MIL-S-19500/183A
AMENDMENT 3
31 August 1994

SEMICONDUCTOR DEVICE, DIODE, SILICON, RF MIXER
TYPE JAN-1N25WA

This amendment forms a part of MIL-S-19500/183A, dated 12 February 1965, and is approved for use by all Departments and Agencies of the Department of Defense.

FIGURE 1. Semiconductor device, diode, type JAN-1N25WA.

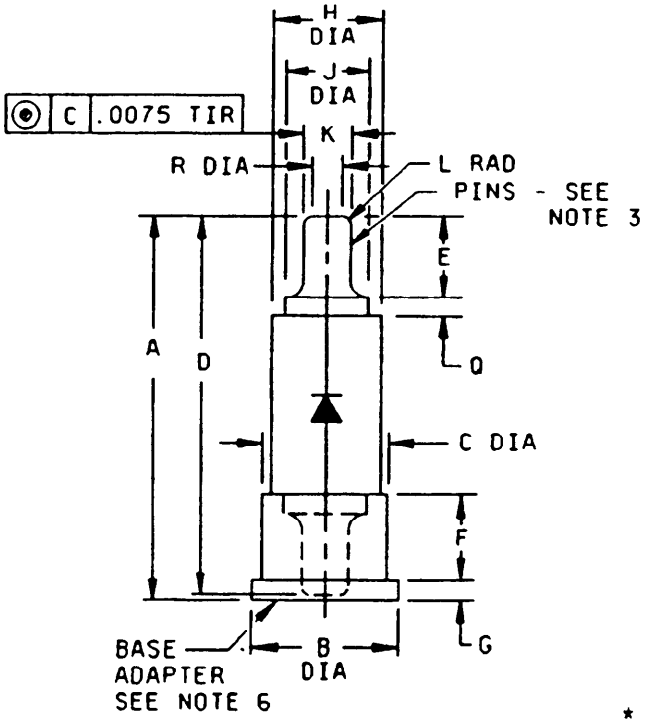
Ltr	Dimensions				Notes
	Inches		Millimeters		
	Min	Max	Min	Max	
A	.800	.840	20.32	21.34	
B	.292	.296	7.42	7.52	
C	.246	.250	6.25	6.35	
D	.766	.792	19.46	20.12	
E	.180	.190	4.57	4.83	7
F	.193	.199	4.90	5.05	
G	.047	.057	1.19	1.45	
H	.222	.240	5.64	6.10	
J	.195	.215	4.95	5.46	7
K	.092	.094	2.34	2.39	3,6,7
L	.030	.046	.76	1.17	7
* Q	.017	.030	.43	.76	7
R		.030		.76	7

FIGURE 2 Removable base adapter, included as a part of type JAN 1N25WA.

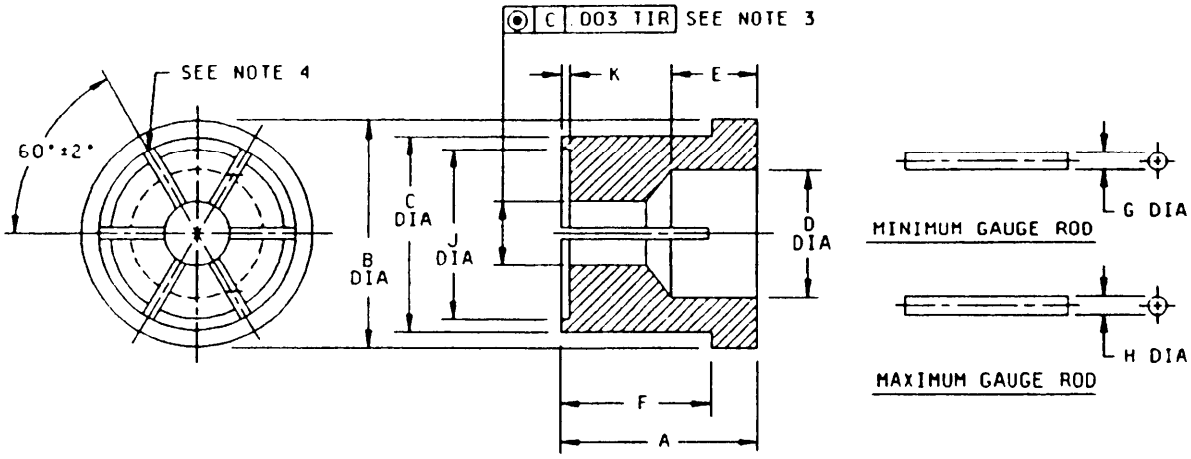
* 1. Dimensions are in inches.
2. Metric equivalents are given for general information only.
3. This diameter should be 0.100 inch (2.54 mm) maximum diameter before closing jaws. This diameter shall then be sufficiently closed, and the adapter so tempered that it will fit on the minimum gauge rod and also on the maximum gauge rod, in each case with a snug fit (for hand assembly).
4. Each slot shall be .013 inch (0.33 mm) minimum, .017 inch (0.43 mm) maximum wide by .185 inch (4.70 mm) deep before closing. The six slots are equally spaced.
5. The material for the adaptor shall be beryllium copper or half-hard brass in accordance with QQ-B-626, composition 22, and shall be gold plated 10 msi minimum.
6. All burrs and sharp edges shall be removed.
